कार्यालय  
अधिशाली अभियन्ता,  
राष्ट्रीय मार्ग खण्ड, लो0नि0वि0,  
बड़कोट (उत्तरकाशी)।

पत्रांक 744 /04 भू 0अ0

विषय:- चार धाम परियोजना(ऑल वेदर रोड) के अन्तर्गत राष्ट्रीय राजमार्ग संख्या-94 (134) के कि0मी0 0.00 से कि0मी0 24.300 (धरासू बैण्ड से सिलक्यारा बैण्ड) तक दो लेन चौड़ीकरण हेतु अतिरिक्त डम्पिंग स्थल एवं लैण्ड स्लाईड जोन के उपचार के लिए 5.969 है0 वन भूमि प्रस्ताव में लगी आपत्तियों के निराकरण के सम्बन्ध में। चतुर्वेस छव.(छव.36902ध2018द्व)

सन्दर्भ:- कार्यालय पर्यावरण वन एवं जलवायु परिवर्तन मंत्रालय क्षेत्रीय कार्यालय (उत्तर केंद्रीय क्षेत्र) देहरादून के पत्र संख्या:- 8बी/यू.सी.पी./06/155/2019/एफ.सी./498 दिनांक 30-06-2020 एवं प्रभागीय वनाधिकारी उत्तरकाशी वन प्रभाग उत्तरकाशी का EDS dated-06.07.2020.

डिजिटल मैप:-चारधाम परियोजना के अंतर्गत रा0रा0 संख्या 94(134) के मध्य डंपिंग यार्ड एवं भूस्खलन भाग के उपचार कार्य हेतु वृक्षारोपण स्थल (क्षेत्रफल 14.00 है0)

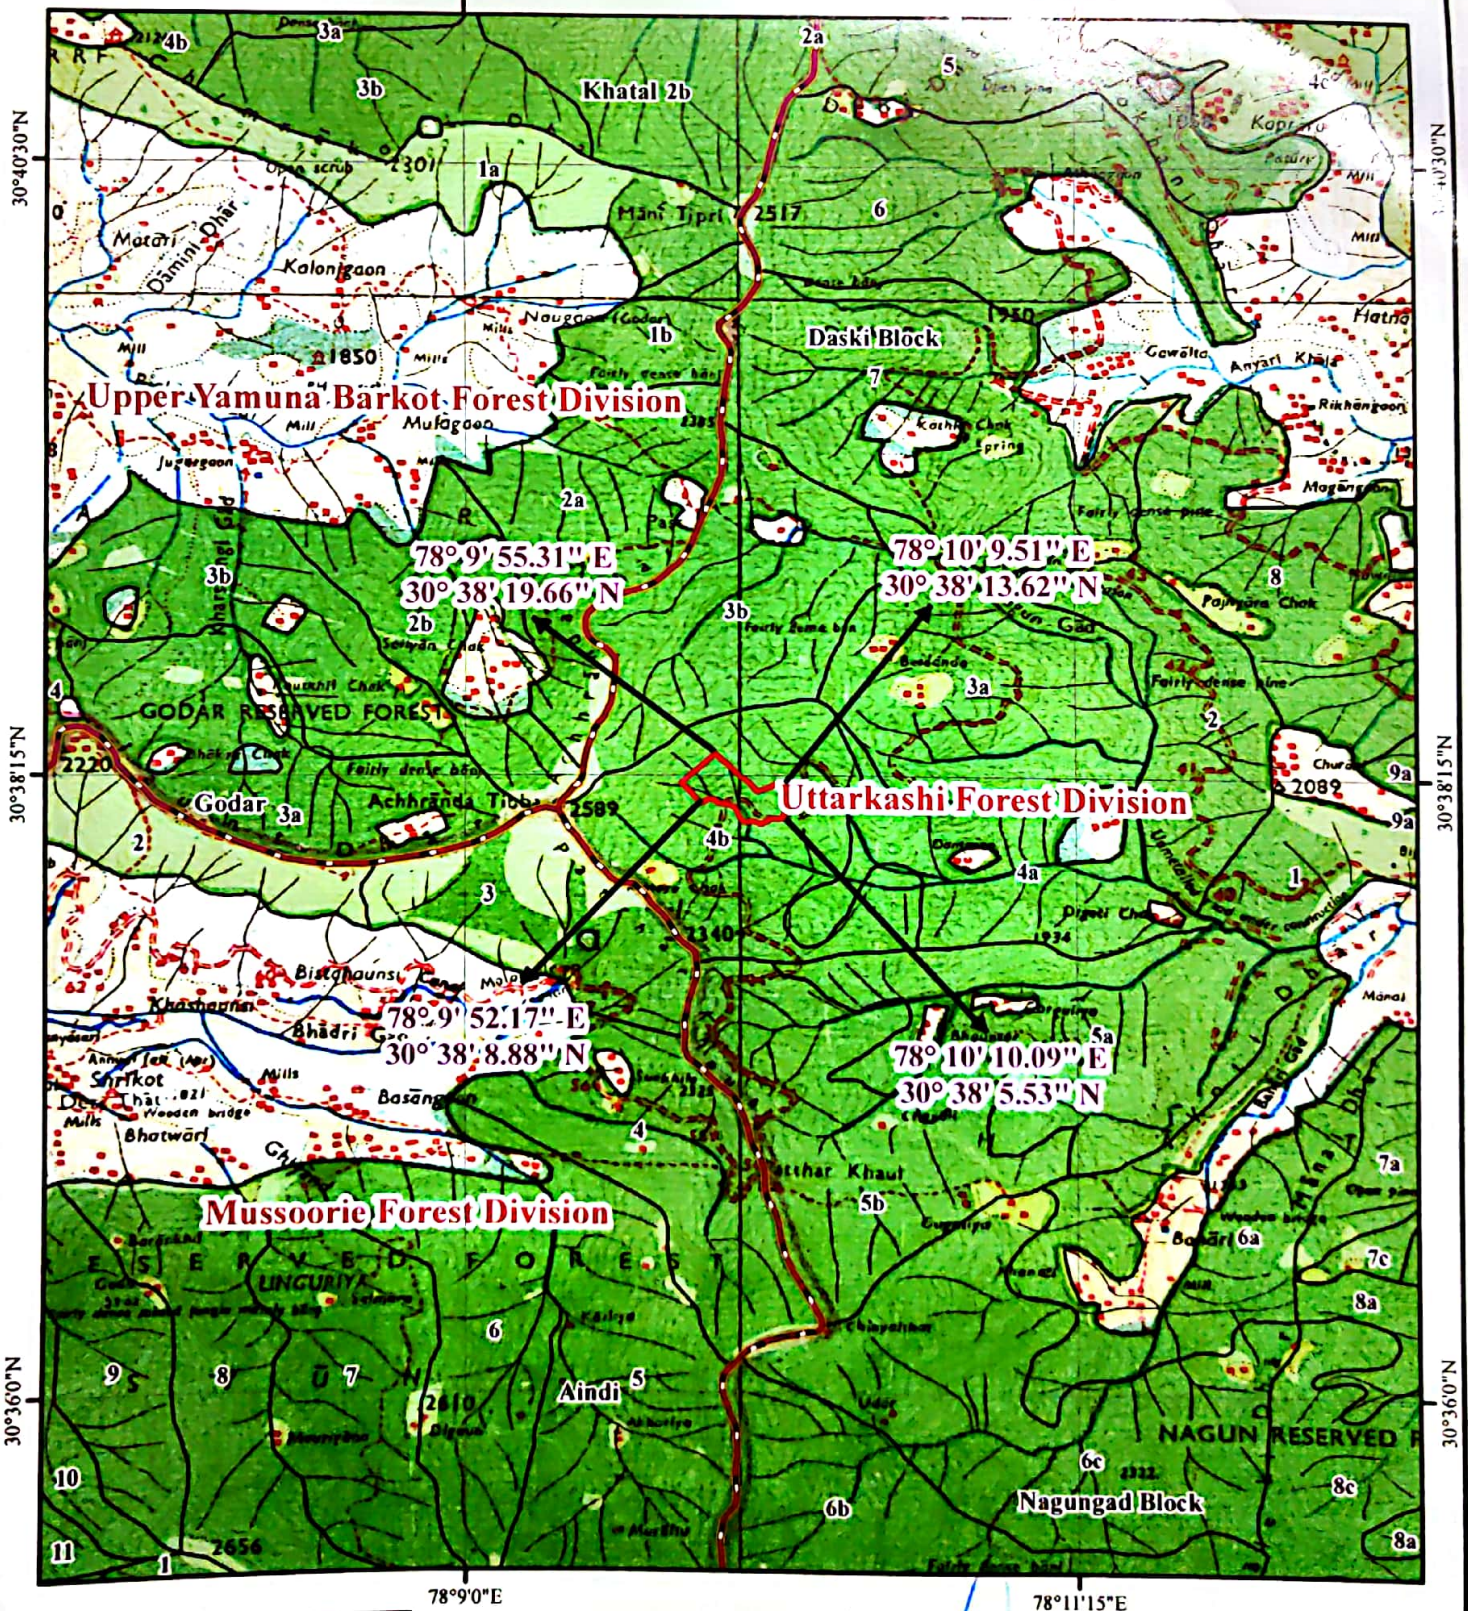
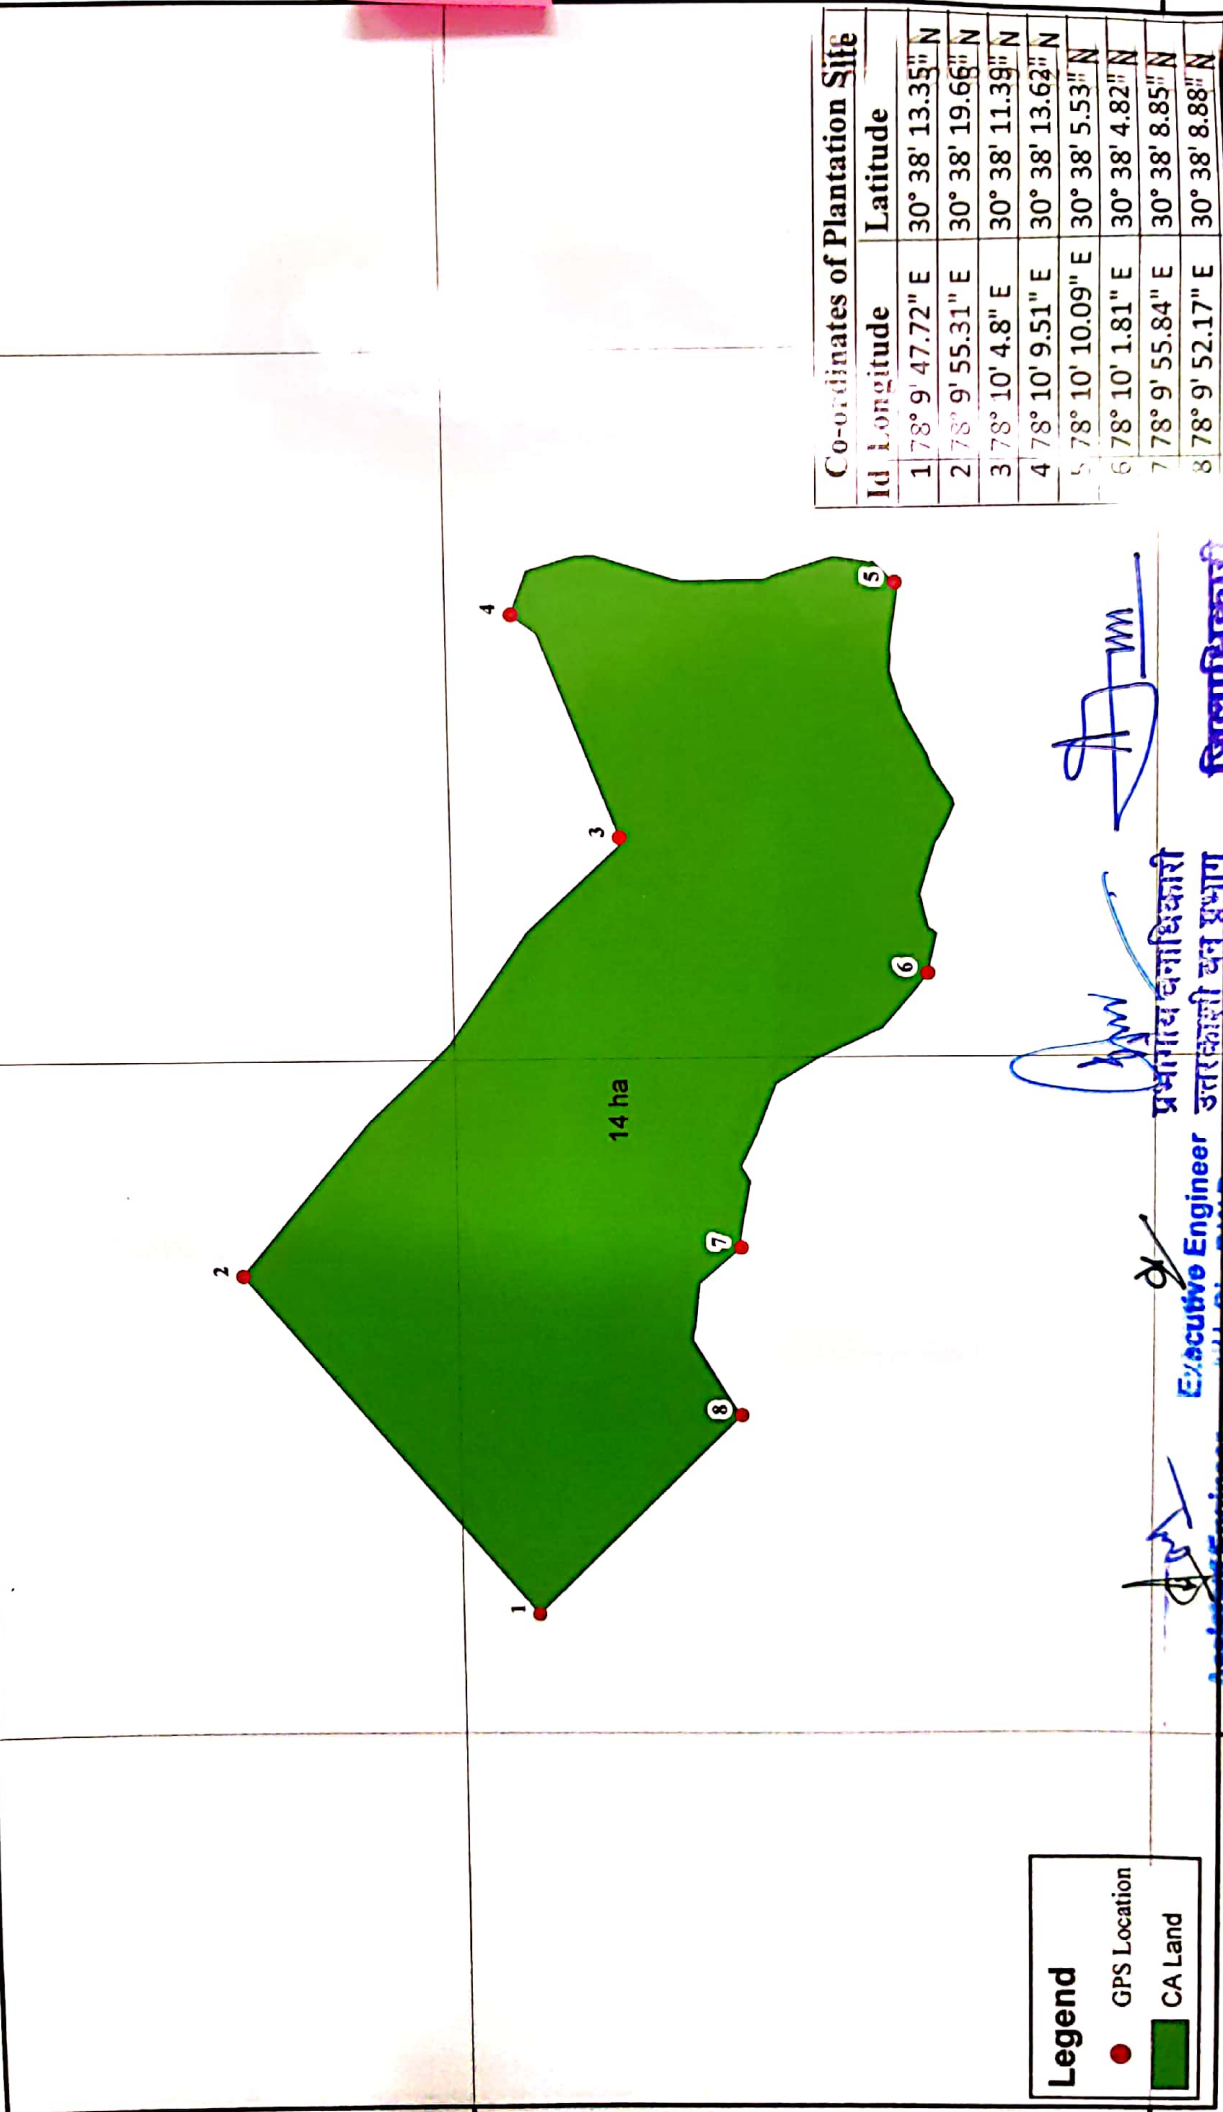
11	As per DSS analysis, 2 ha area comes under MDF proposal on RF area. Hence, the state govt. may submit another 2ha area suitable for plantation.	Appropriate corrections have been made in digital map of CA land. Another 2ha. area suitable for plantation has been added. Therefore digital map and geo reference map consisting total area 14ha. for CA land has been attached and uploaded online at Form-A Part-1 additional information detail.
12	The location of CA site is mentioned in Nagungad compartment no. 3b in Para-13(i) of Part-II but the location appear to be in compartment no. 4b in the sol toposheet map uploaded at Para (iv) of Part-II.	Appropriate corrections have been made. 14ha CA land lies in compartment no.-4b (Nagungad) of Dharasu Range. CA site suitability certificate in this regard has been attached and uploaded online at Form-A Part-1 additional information detail.
13	CA site suitability certificate uploaded at Para-13 (v) of Part-II has not been signed by DFO.	CA site suitability certificate duly signed by DFO and has been attached and uploaded online at Form-A Part-1 additional information detail.
